**From:** Shannon Wilbur  
**Sent:** Wednesday, September 19, 2018 2:13 PM  
**To:** Linda Ann Kuller  
**Subject:** RE: Revised Draft Standard Detail for Lopez Village  
**Attachments:** 2018-19-18 parking SW.pdf

PARKING LAYOUT

LOPEZ VILLAGE STREET STANDARDS

913a

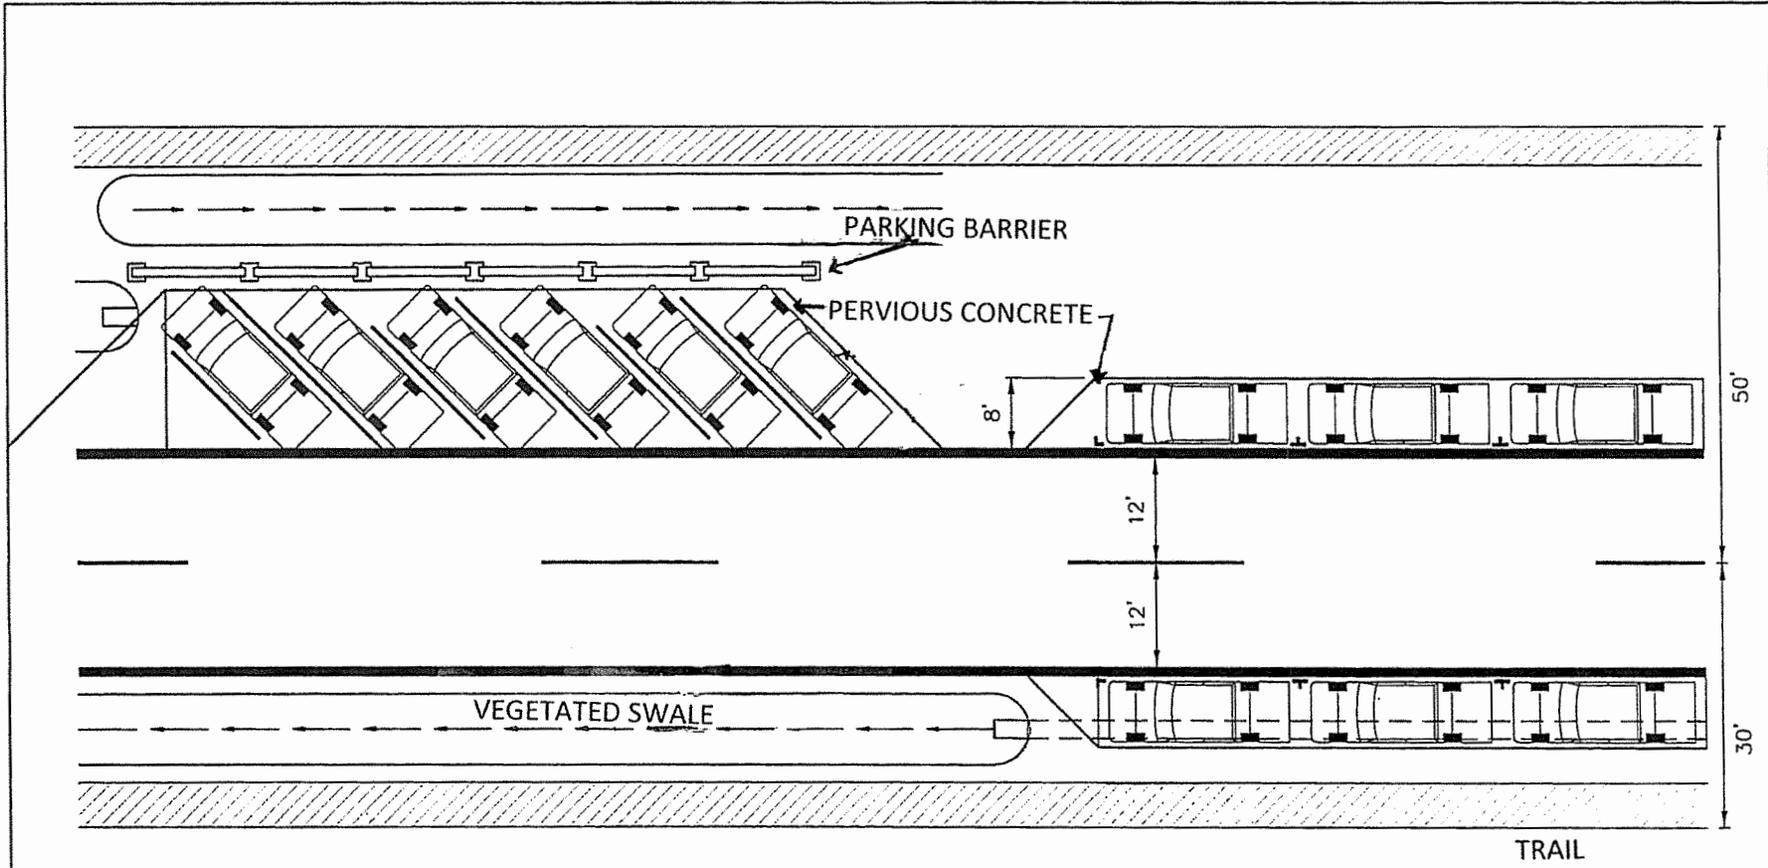
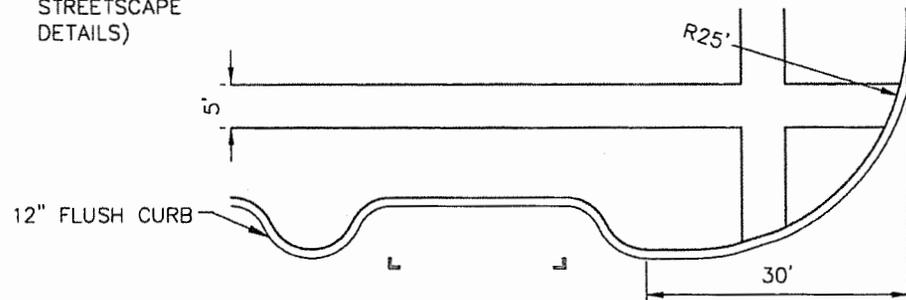
Here you go Linda. There is the original parking plan, now 913a, and a second option parking plan, 913b. As with all of our other standards, they are stamped as Draft.
